VEHICLE RECALL

**G-02509
December 2002**

SUBJECT: VEHICLE RECALL (U.S., EXPORT)

**Fuel Line Harness Inspections and Retrofits on
Certain 7300, 7400 and 7500 Models Built from
7/19/01 through 7/16/2002 with Right Side Frame Rail
Mounted Fuel Filter and with a Left Side Mounted
Fuel Tank**

**Figure 1: ABOVE: GOOD ROUTING
NO ACTION REQUIRED.**
The harness is between the engine breather tube and the engine.

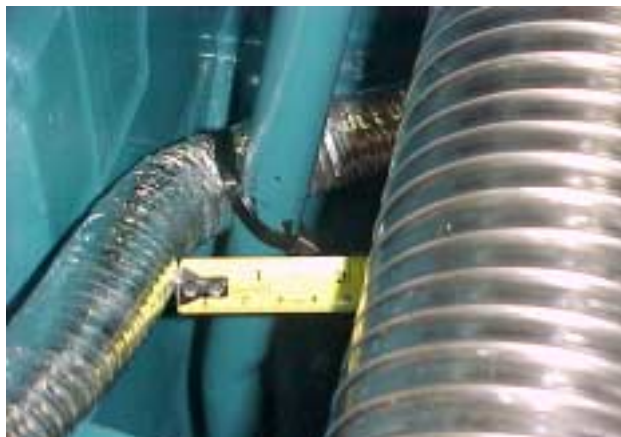
4. **Inspect the fuel line routing.** From the right side wheel well, locate the fuel line harness as shown in Figure 1. The fuel line harness must be routed behind the engine breather tube or between the engine breather tube and the engine as shown in Figures 1 and 2. If the fuel line on your vehicle is routed as shown in Figure 1 and 2, it passes the inspection and you should go directly to steps 22 and 23. If the fuel line is routed for the two different exhaust systems, as shown in Figures 3 or 4, a new fuel line harness must be installed and you must continue to step 5 to complete this recall procedure. Reference the **PART INFORMATION** section and obtain the correct fuel line harness and routing kit.

Figure 5: Routing From Bell Housing Forward, Routing Kit 8900088R91 for Vehicles With A Smooth Exhaust Pipe

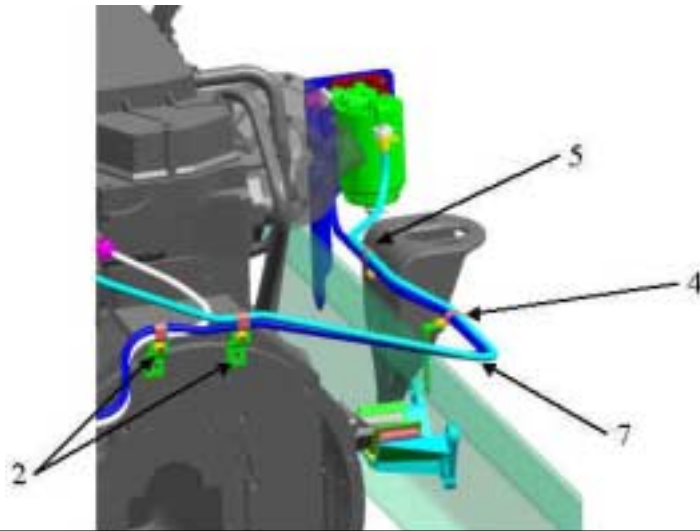
15. Lay the fuel line harness in place. Use Figures 5 and 7 for vehicles with the exhaust system that has the smooth exhaust pipe shown in Figure 3. Use Figures 6 and 7 for vehicles with the exhaust system that has the flex exhaust pipe shown in Figure 4.

- Items:
- 2. Two Z-style extension clips, p-clamps, M8 nuts/bolts
 - 4. One L-shaped extension clip, p-clamp, M8 nut/bolt, mounted to upper/forward engine mount
 - 5. One clamp, M6 bolt/nut on cab mount
 - 7. Fuel harness

Figure 7: Routing From Tank to Bell Housing & Pump, Applies To All

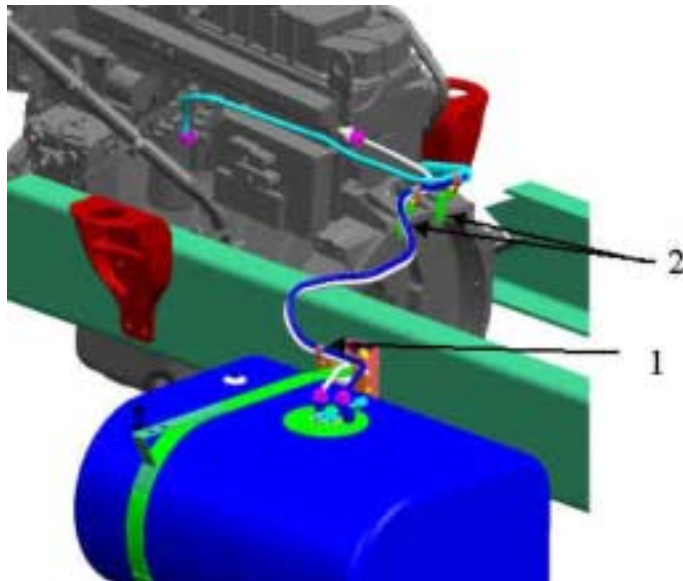
16. Beginning at the fuel tank, install the new harness clips up to the bell housing (see Figure 7). Clips are to be installed at the black tape locations on the harness.
17. From the bell housing forward, the instructions are different depending on which harness is being installed. Using the appropriate Figure, 5 or 6, install the clipping from the bell housing forward.
18. Connect all the fuel lines and bleed the fuel lines as necessary.
19. Install the engine cover and reposition the floor mat.
20. Install the kick panel, sill plate, shifter assembly, cup holder and the seat.
21. Install both hood fender extensions.
22. Install the engine splash shield.
23. Close the hood assembly and remove the wheel chocks.

Items:

1. Save original clamping hardware and reuse during installation.
2. Two Z-style extension clips, p-clamps, M8 nuts/bolts
